Parts Change Information

Subject: Modification of Damper; FB **Issue No.: 19510**

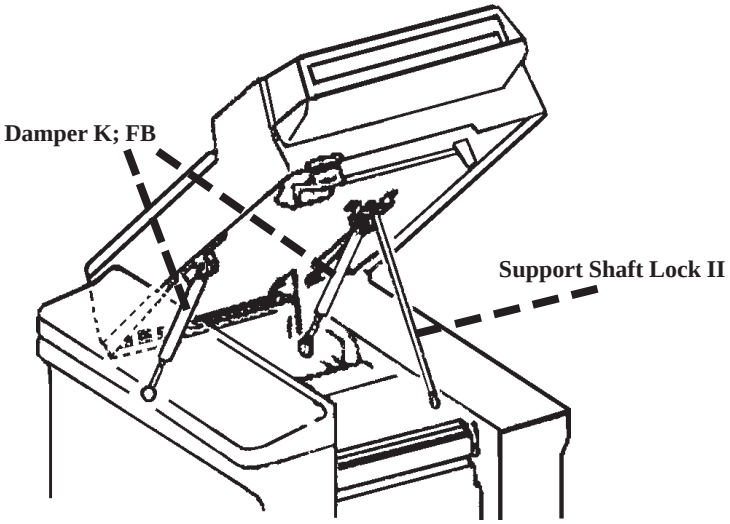
The diameter of the Damper; FB has been increased.

The Support Shaft Lock has been replaced by the Support Shaft Lock II.

When the original Damper units are replaced with the Damper K; FB units, the original Support Shaft Lock must be replaced by the Support Shaft Lock II.
